KMR.CDD.LyQ.1925.02

With reference to his application dated 4-3-1925 with a plan for the proposed building on plot No.80,K-4,Lyari Quarter,Mai Vishinbai per Daloomal Nathoomal is informed that Town Planning scheme is being prepared for this quarter and therefore until the scheme is completed plans for building can not be passed.

I beg to inform you that I intend building Plan of Proposed
Additions & Alterations on plot No. 80
Survey Sheet No. K-4. Situate in Road
Street, Gyaree Quarter.

PLAN OF PROPOSED BUILDING
ADDITIONS & ALTERATIONS TO BE BUILT ON PORTION OF
PLOT NO. 80 SHEET NO. K-4 LYAREE Q.E.
SCALE 8" = 1' INCH

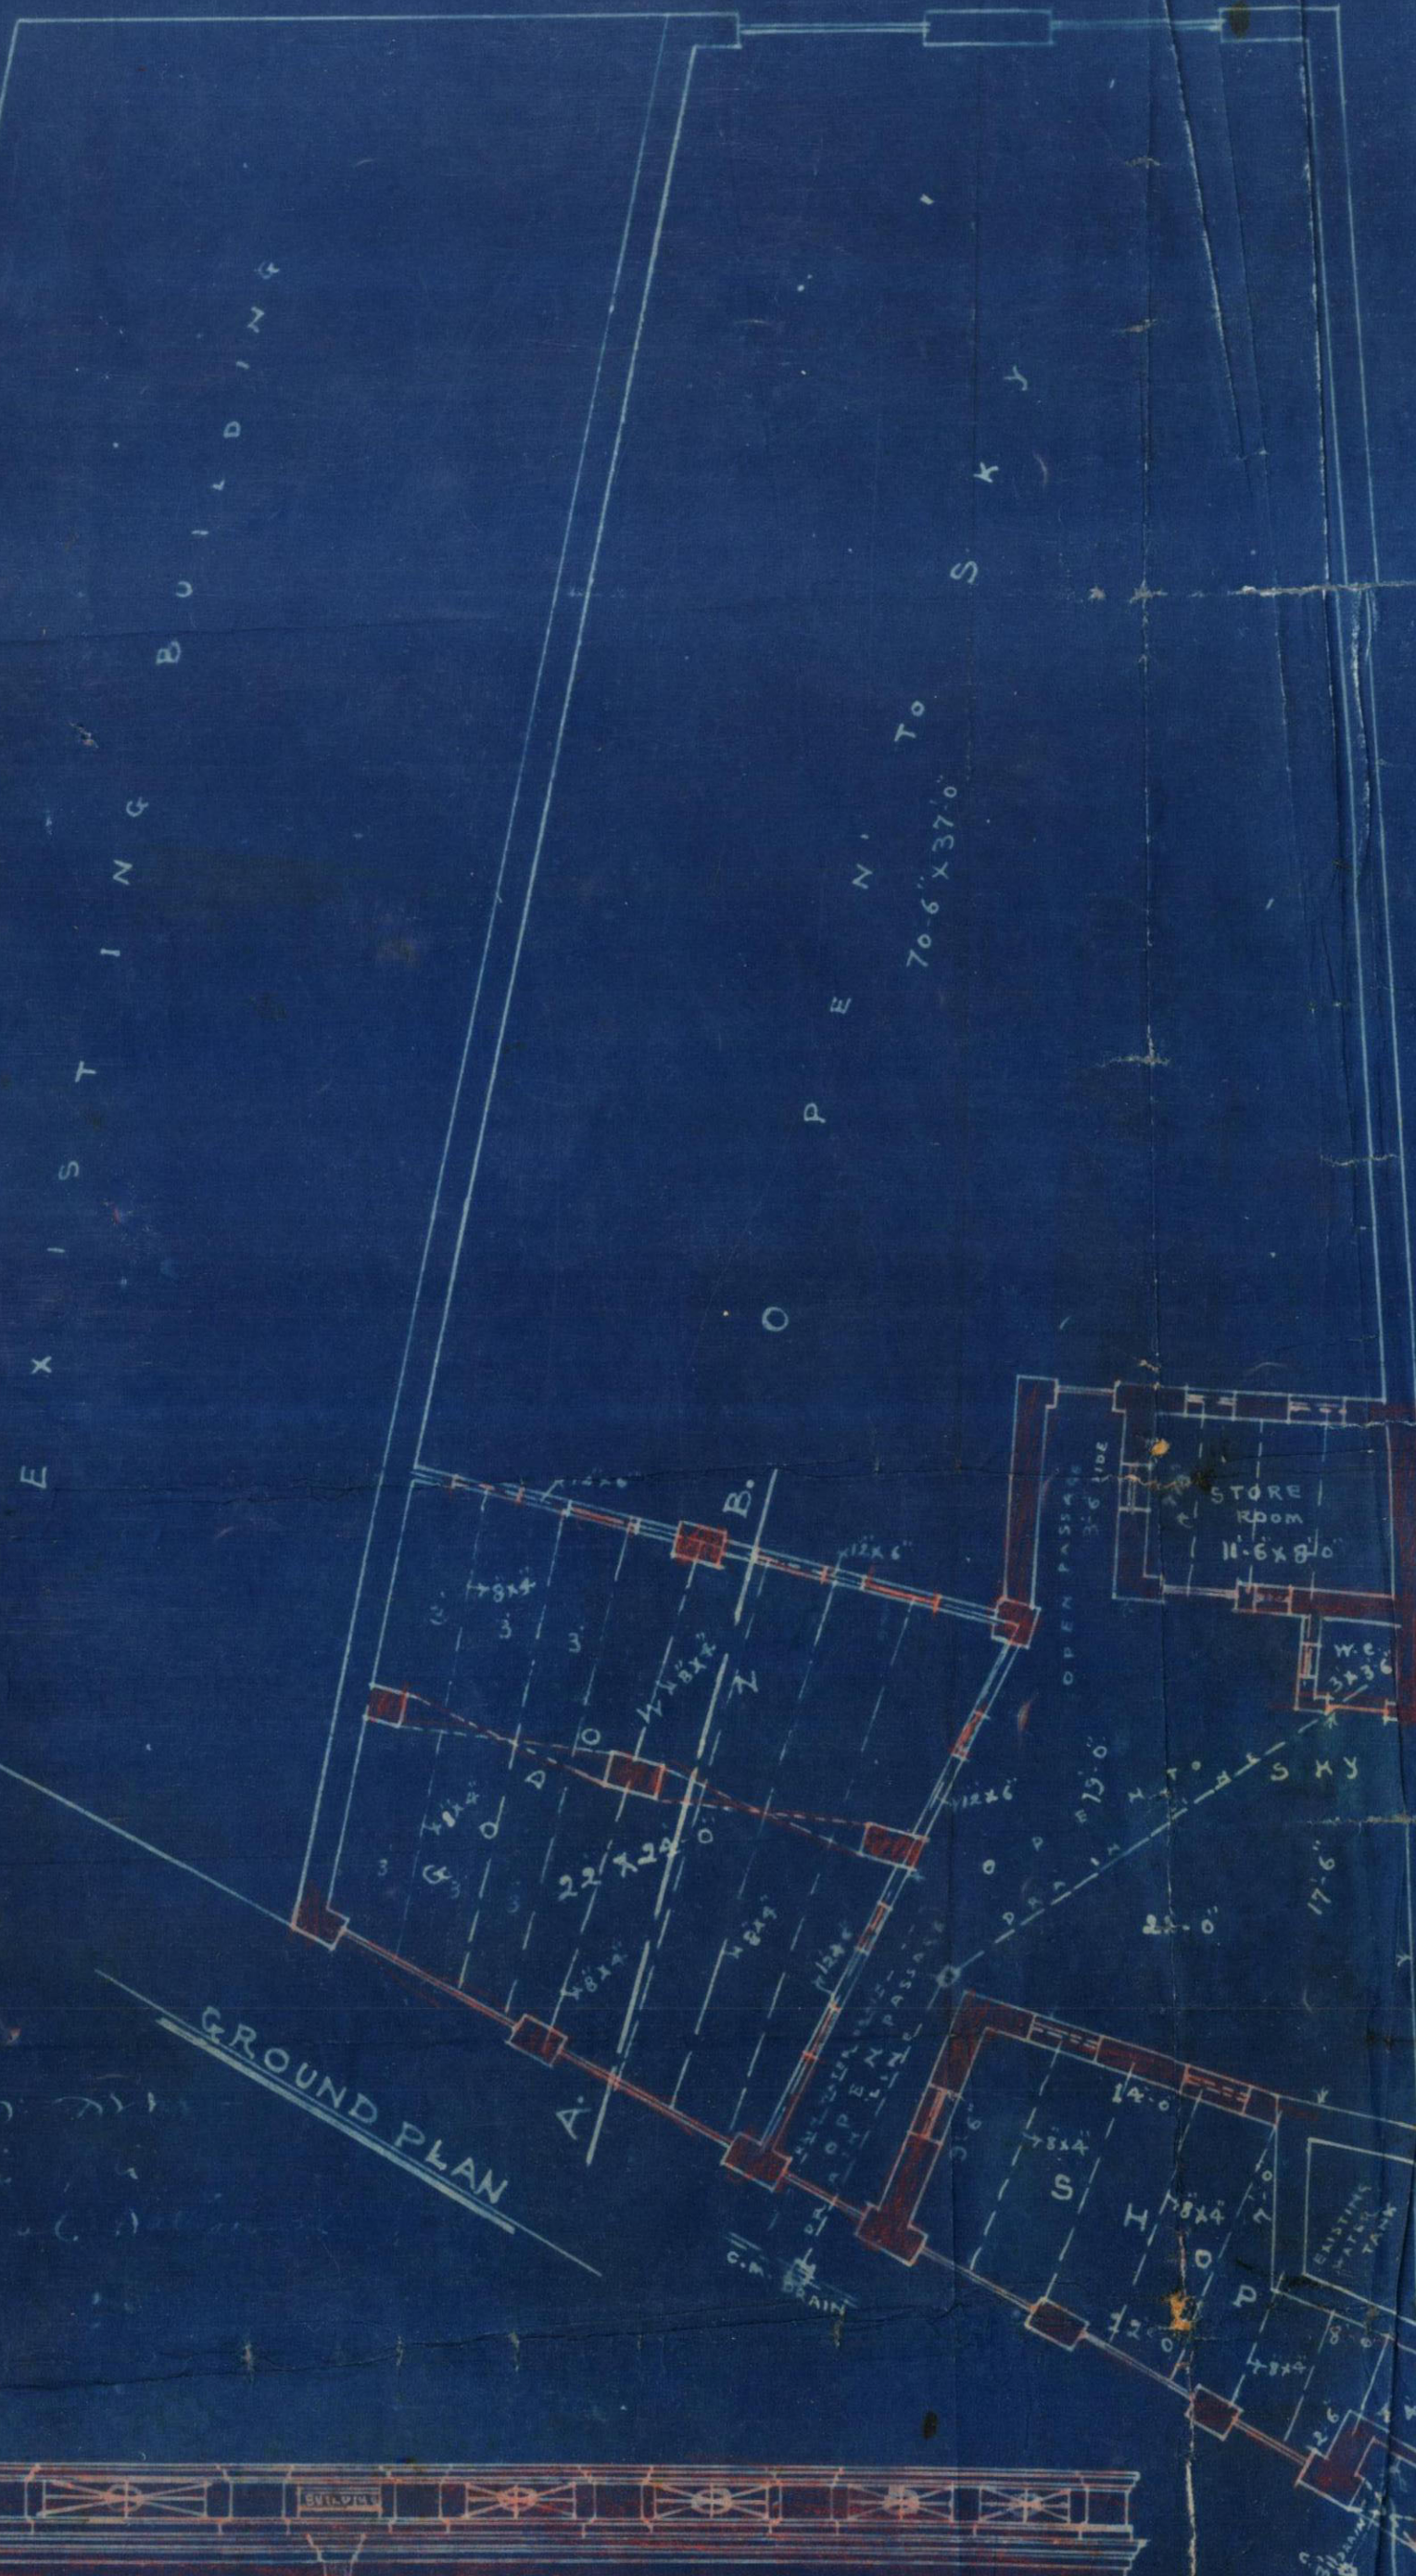
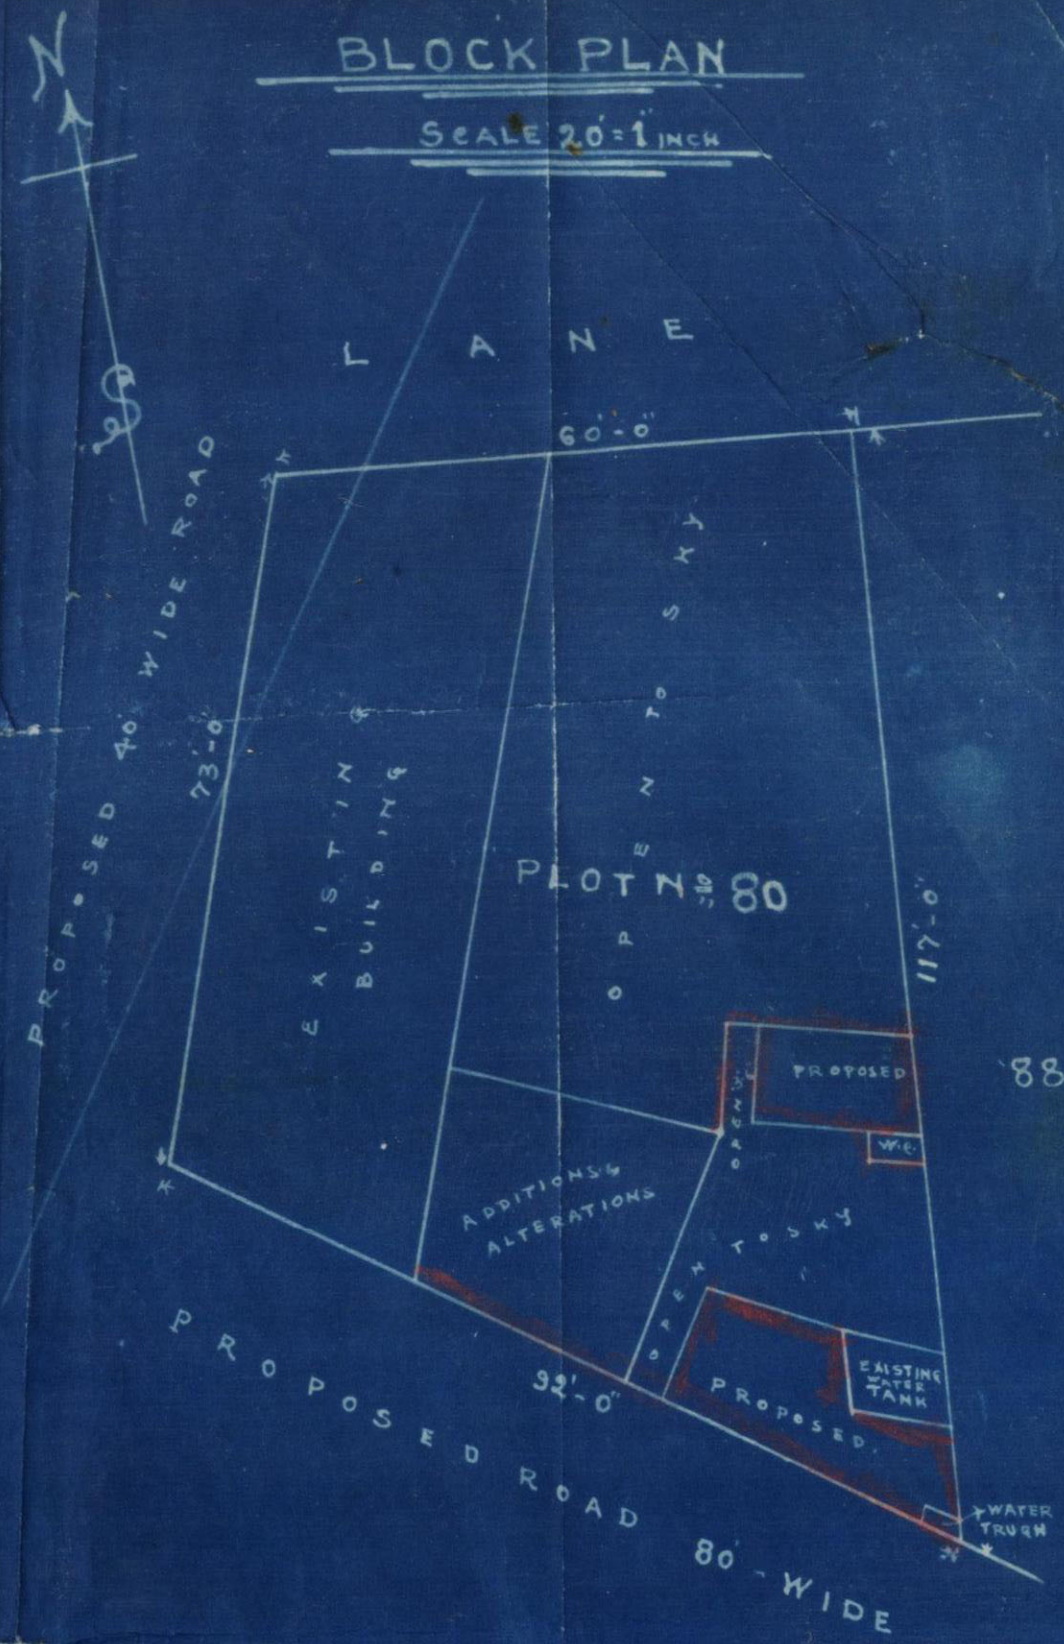
Please inform the owner that
as his plot is ~~not~~ included in town plan, Section
is being prepared for Dyari the plans
cannot be considered at present.

Submission of. Beams in godowns should be 9x4". & Beams on p. wall should be 13x7". The plans can only be considered if the plot does not affect the drainage scheme -
